Access Compliance Report

Public Rights-of-Way

(Curb Ramps)

Intersection ID: 6328	Main Street: E_W_T_HARRIS_RA	Cross Street: UNIVERSITY_CITY_BV	Location: NE
ADA ID: 62AFF89A7AA7	Ramp Type: Directional1	Initial Pass/Fail: Pass	Overall Compliance: No
Severity Score: 17.5			
Codes/Mitigation Info/Possible Solution		Field Measurements/Component Compliance

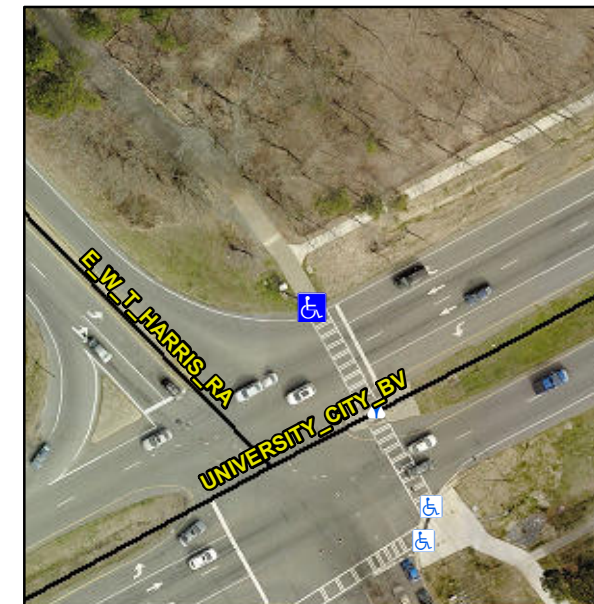
NO CURB

**R304.2.2-Perp, R304.3.2-Para,
R305.1.4, R305.2, R302.7, R302.7.2**

**Remove & Replace Entire Ramp.
Grind Gutter Lip.**
